PEER REVIEW STATEMENT (FINAL) – MT PLEASANT FINAL VOID

ATTENTION:	Tegan Cole, NSW Dept of Planning Industry and Environment (DPIE)	
FROM:	Hugh Middlemis, Principal Groundwater Engineer, HydroGeoLogic (HGL)	
REFERENCES:	8 February 2022	Mount Pleasant Optimisation Project (SSD 10418)(EPBC 2020/8735)
SUBJECT:	Mount Pleasant Optimisation Project Rehabilitation and Mine Closure. Targeted Peer Review of final void Groundwater Impact Assessment - Final.

Figure 1 - 2016 water table contours (after AGE 2020a, Figure 5.8) and predicted particle pathlines post-mining for no void scenario (after AGE 202b, Figure 2)

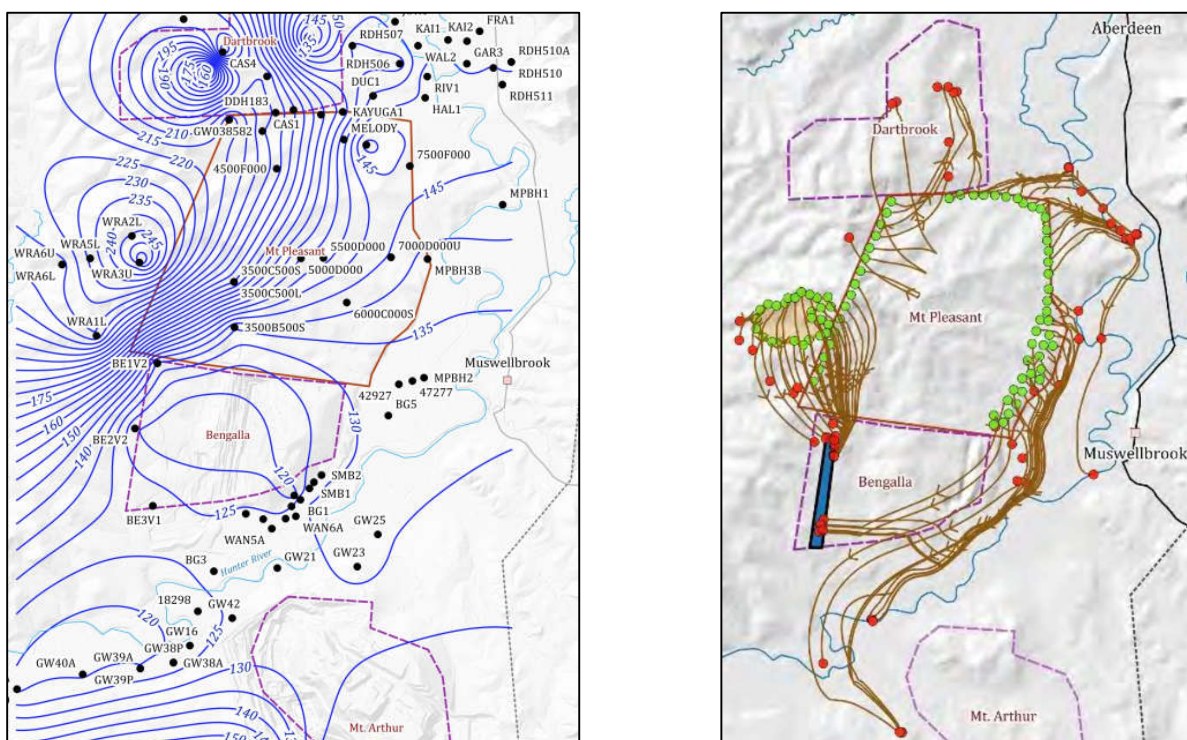
Regarding the premise of maximising groundwater flows from the Eastern Out-of-Pit Emplacement to the final void, it has not been made clear why such flows should be maximised, but it is presumed that it would be a quite reasonable mitigation measure to minimise the risk of poor quality flows east towards the Hunter River (ie. a stable final void lake/sink helps protect the River). However, this has implications for the final void lake, in that poor quality flows from the eastern emplacement would impact the lake water quality, although that has not yet been adequately assessed, as noted in the initial review. If the flows through the emplacements are not poor quality, then the documents reviewed do not make the reasoning readily apparent for directing flows towards a (stable) groundwater sink and away from the River (ie. the final void option does not replicate the 2016 gradients towards the river that are shown in Figure 5.8 of AGE 2020a; see Figure 1 below, left frame).

The initial review noted that relatively high recharge rates were applied to the waste rock emplacements, including for the 'no void' scenario (eg. 'spoil' recharge is 6% of annual rainfall, compared to just 3.2% for alluvium and 2.8% for Triassic Sandstone; AGE 2020a, page 32; AGE 2020b). This 6% spoil recharge rate applied to Mt Pleasant is three times higher than the 2% spoil recharge rate reportedly applied to the Bengalla and Mt Arthur mine spoil areas (Table A.2.5 of AGE 2020a); the difference is not justified. The consequent high water table mound post-mining at Mt Pleasant was reportedly the main driver for flows from the eastern out-of-pit emplacement towards the Hunter River (Figure 1, right frame), which was considered unacceptable.

The groundwater assessment remains deficient in terms of the 'no void' option because it still has not investigated whether reduced recharge rates would reduce the water table mound and thus minimise flows towards the Hunter River (eg. consistent with the 2% spoil recharge rate applied to the Bengalla/ and Mt Arthur mines, or possibly lower, such as by land surface treatments to Mt Pleasant emplacements). The groundwater assessment also does not provide details on the quality of these groundwater flow components, or the potential impact on the floodplain or river. The implication is that the 'no void' option may have been unreasonably discarded and that further investigation of the 'no void' option may be warranted. However, the final landform premise adopted (final void lake/sink) is consistent with the existing approvals and the current approved MOP, so further sensitivity/uncertainty scenarios may arguably not be warranted for the no void case, although investigation of the final void scenario recharge sensitivity/uncertainty is warranted.

Figure 2 - MPO final void lake stage-inflow curve (after AGE Attachment A to Mach 2021c)

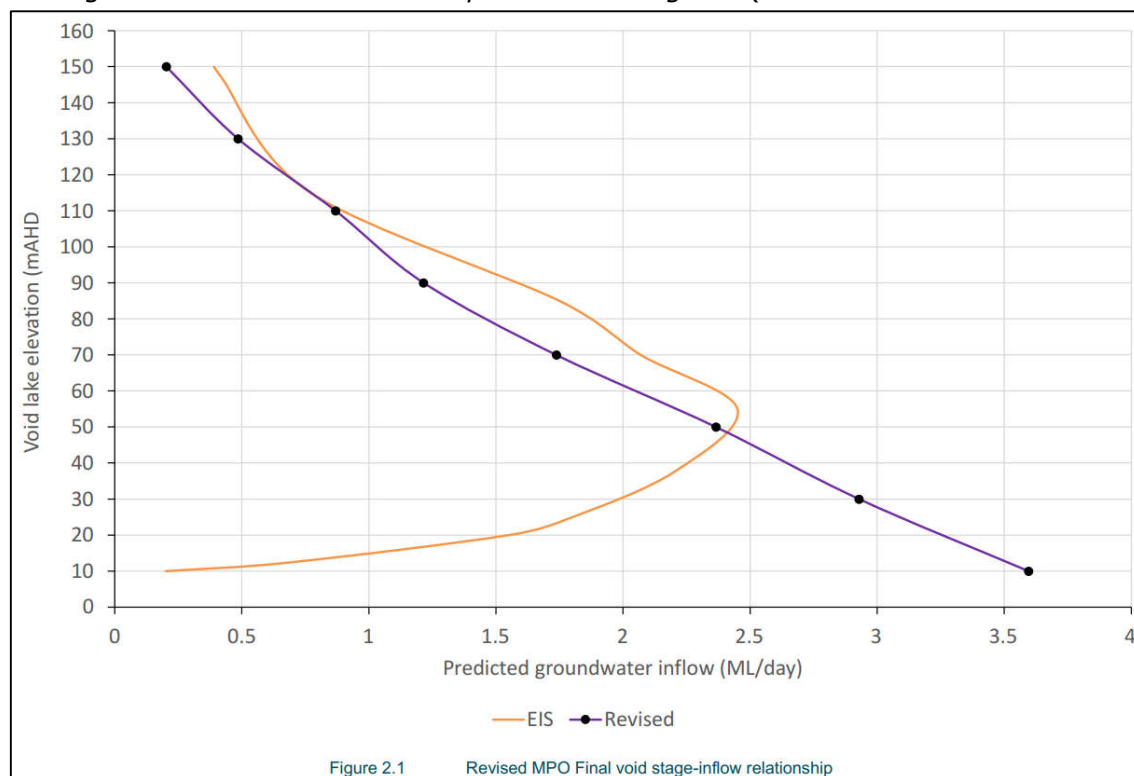
The response report (MACH 2021c) has resolved the issue of the unrealistic void lake stage-inflow curve presented in the EIS, by presenting a revised curve that displays 'a smooth reduction in groundwater inflow as the void water elevation increases and the flow gradient towards the void eases.' The revised stage-inflow plot (Figure 2.1 of Attachment A to MACH 2021c, presented as Figure 2 below) is aptly described by the Jacobs peer review statement as having 'a much more intuitive shape than the original' (Attachment B to MACH 2021c).

The revised stage-inflow curve is described as being derived via an 'alternative modelling methodology', but that is yet another example of the many statements with positive spin in the response document (see also previous section and later this section). The Jacobs peer review report notes that original method is 'less relevant' to the assessment than the revised method, and that it 'cannot be used to indicate equilibrium inflows at various stage elevations', which essentially confirms that the original method was actually incorrect, as my initial review indicated.

The revised stage-inflow curve was input to the GoldSim water and salt balance modelling (Attachment C to MACH 2021c). Revised results indicate a long term final void lake level of 75mAHD, which is 15m below the original level. This is presumably due to the revised inflows at lake levels of 50-100 mAHD being lower than for the original (incorrect) stage-inflow curve.
